**FUTURE MELBOURNE (PLANNING) COMMITTEE  
SUPPLEMENTARY REPORT**

**ARDEN-MACAULAY STRUCTURE PLAN**

**7 February 2012**

**FINAL DRAFT ARDEN-MACAULAY STRUCTURE PLAN –  
REPORT ON THE COMMUNITY CONSULTATION**

Figure 3.17 Proposed building heights and setback controls.

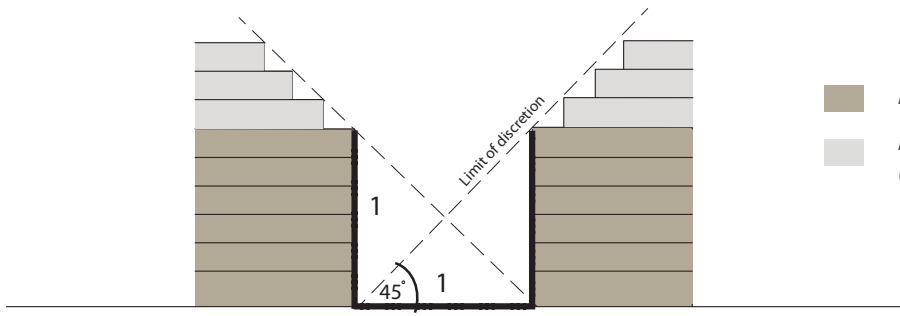
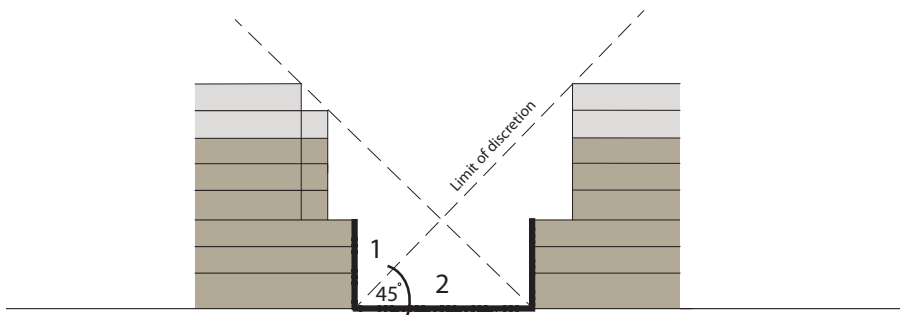
Author	Individual/ Organisation	Comment	CoM Actions	Explanation
		<p>cc. Figure 3.17 - Proposed building heights and setback controls - The maximum building heights along the Moonee Ponds Creek should be amended to 5 storeys (14-16m) to comply with the MPS Incorporated Plan Overlay 5 - Moonee Ponds Creek Concept Plan (see page 35), not 20m or 30m as depicted in Figure 3.17.</p> <p>dd. It should be noted there is little likelihood of the SPI AusNet West Melbourne Electricity Terminal site, bounded by Arden St, Lloyd St, the Moonee Ponds Creek and the railway line, being redeveloped. SPI PowerNet made clear at recent Planning Panels Victoria MSS/Am C162 hearings that it is planning to continue the existing use for another 50 years with major upgrade scheduled to commence in 2012.</p>	<p>cc. Remove references to the discretionary height control of five storeys underneath heading regarding the Incorporated Plan Overlay 5 - Moonee Ponds Creek Concept Plan.</p>	<p>cc. a. The reference to the Incorporated Plan Overlay (IPO) 5 – Moonee Ponds Creek Concept Plan imposing a discretionary height control of five storeys is an error in the final draft. There is no discretionary height control designates within the IPO. Any development proposal will need to comply with the building height and setback controls of the City of Melbourne's Urban Design policy, Clause 22.02 (Sunlight to Public Places) which prevents overshadowing public open space between 11am and 2pm.</p>

Author	Individual/ Organisation	Comment	CoM Actions	Explanation
		<p>However on reviewing the current plan (fig 3.17 pg 51) this appears to not be the case. A 20 metre height restriction along both sides of Macaulay Road with no setback remains in place. Once again, I wish to restate my view that it is entirely inappropriate that there be no set-back or height restrictions on the street frontage of Macaulay Road from Rankins Road/Eastwood Street down the hill to the creek bed/overhead freeway. I believe the triangular area of properties at the corner of Macaulay Road, Rankins Road and Eastwood Street, directly facing the Kensington Railway Station to be of historical significance and worthy of preservation. While this area only adjoins the area of the Structure plan – it will no doubt be greatly impacted by the Arden Macaulay Structure Plan.</p>

<b>Minor Changes</b>		
<b>Item</b>	<b>Proposed Change</b>	<b>Reason for Change</b>
3.9	Amend legend for Built Form to remove 40m as none proposed and change 14-16m to 14m Fig 3.17	No 40m height limit is proposed and 14-16m is ambiguous.

*Figure 3.12 Principles of good street design*

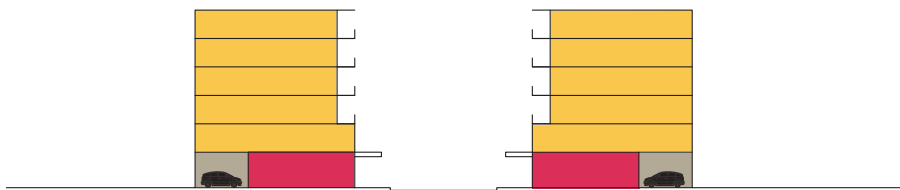
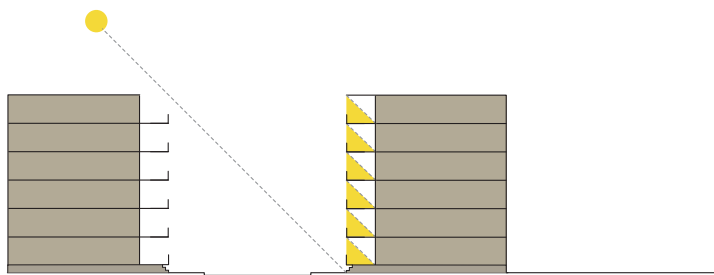
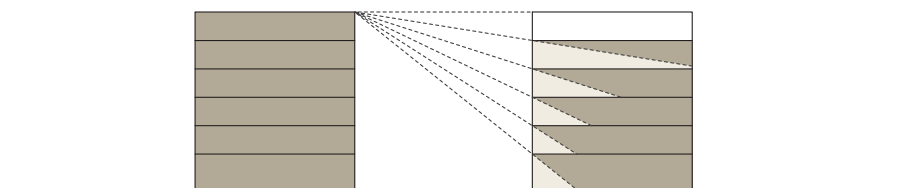
Author	Individual/ Organisation	Comment	CoM Actions	Explanation
		<p>q. Strategy 3 - "To achieve these criteria" &amp; Figure 3.12 - As shown by the examples in Appendix A, a 1:1 building height to street width, with no upper storey setbacks is too large. Six storey buildings on either side of a 20m wide street will 'canyonise' the street leading to poor amenity. Buildings will adversely dominate the streetscape and lead to poor residential and streetscape amenity, which is against the many objectives, principles and strategies in the structure plan. For example, the criteria (no. 1) to provide 5 hours of sunlight to ground floors within the streets with residential uses is pure 'mickey mouse' as the structure plan encourages a vertical mix use of uses through buildings with retail on ground floor, minimum 4m retail/ commercial/ 'convertible' ground floor heights so no sunlight will be required at any level of the 20+m buildings where the ground floor is retail/ commercial! And the discretionary building heights the structure plan proposes, a 1:1 ratio will be meaningless.</p>	<p>q. Incorporate additional sentence into Chapter 3, Strategy 4 as follows: 'The proposed height control at the street frontage or property boundary are mandatory. Beyond the street frontage or property boundary, the height limits proposed are discretionary. Any discretion must comply with the setback conditions as outlined in Figures 3.13 to 3.16.' Update Figures 3.13 - 3.16 as per Figure C (in attachment 2).</p>	<p>q. Provide clarity on extent of mandatory and discretionary controls and illustrate design criteria for discretion.</p>

**Figure B. Updated version of Figure 3.12 in Final Draft**

Figure C: Proposed Residential Interface Conditions

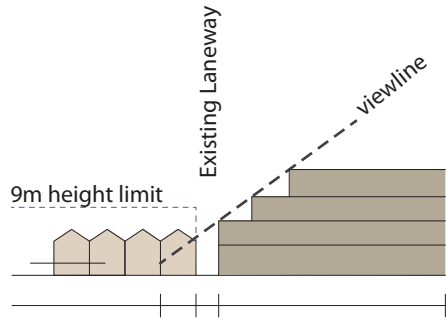
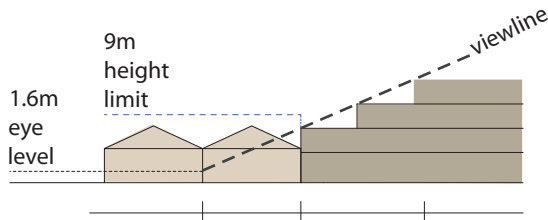
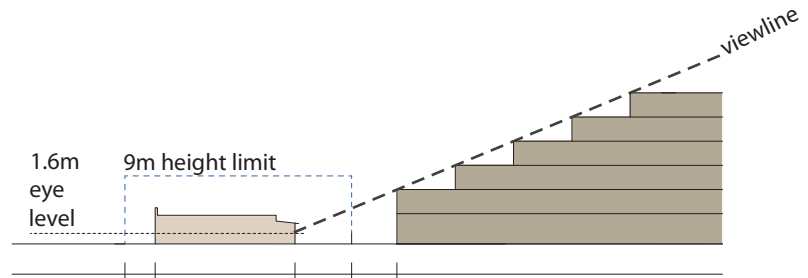
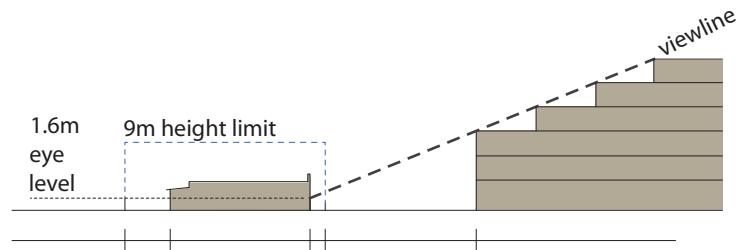
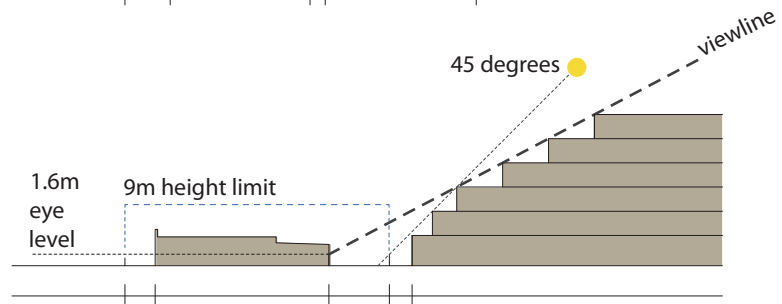
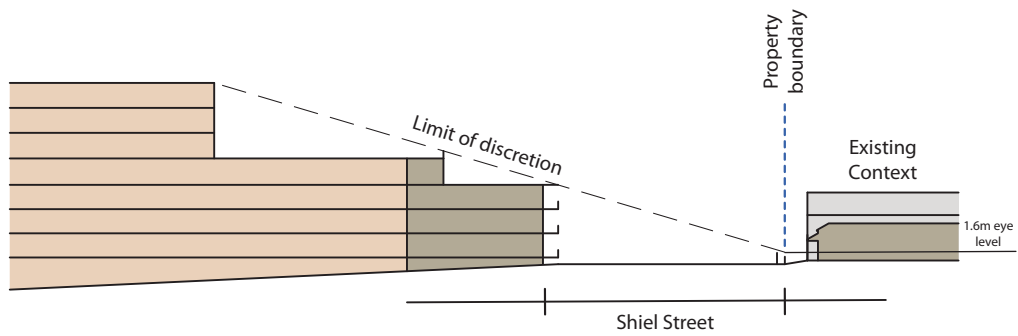
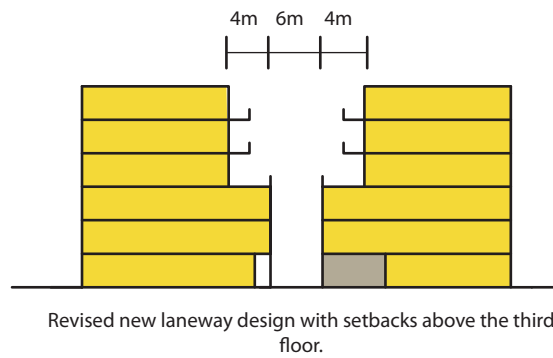
Author	Individual/ Organisation	Comment	CoM Actions	Explanation
		<p>d. 10.5m interface in many areas will result in new structures dominating the existing residences. This is particularly the case where URA's adjoin low-scale residential properties or laneways. The 10.5m are too narrow and the change to 20m is too abrupt. The section diagrams shown on pp. 132-133 are alarming and indicative of these concerns. An incremental increase in building height and scale is required.</p> <p>e. We propose lower building heights at interface sites, no more than one storey higher than the existing height of residential dwellings, and ground-level landscaping and courtyards adjoining backyards/laneways. This is also likely to result in achieving more varied dwelling types/household sizes to promote a diverse population.</p>	<p>d. e. Reduce height controls at the interfaces with existing residential areas and include updated diagrams into plans as shown in Figures A and C in Attachment 2.</p>	<p>d. e. To ensure an appropriate transition of development scale and heights from stable residential areas to the urban renewal areas to protect existing residential amenity and character.</p>

Author	Individual/ Organisation	Comment	CoM Actions	Explanation
		<p>(continued) Even a height of 10.5m, which is applied at many sections of the interface between the proposed mixed use zone and existing residences, would have severe impact on Rankins Road. Replace the proposed 20m height limit with a stepwise design of a scale that reflects the existing built form.</p>

Figure D: Proposed development controls in URA (non residential interface)

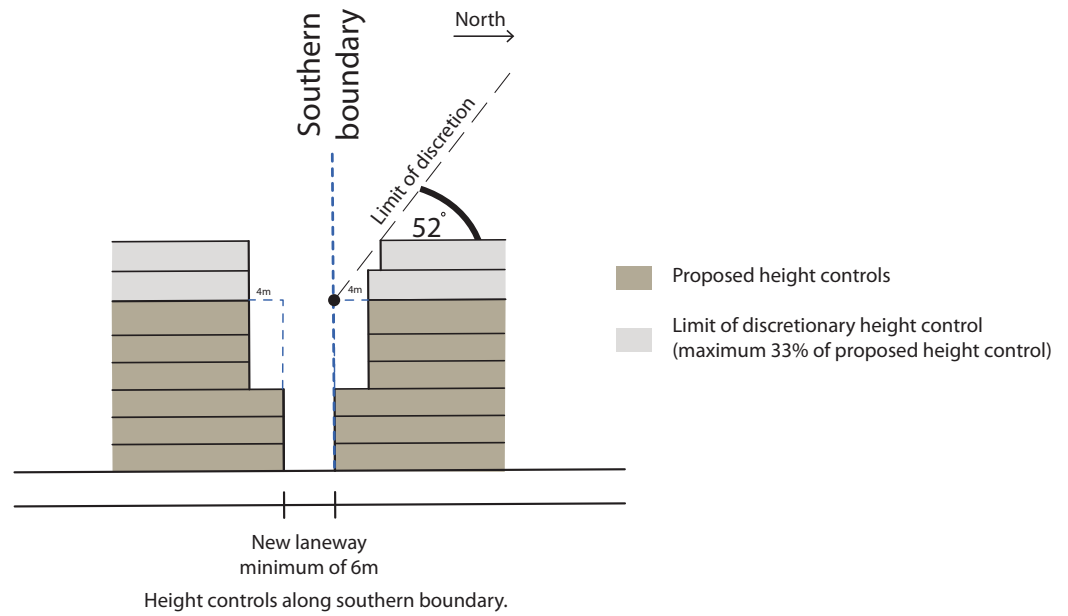
Revised Shiel Street setbacks
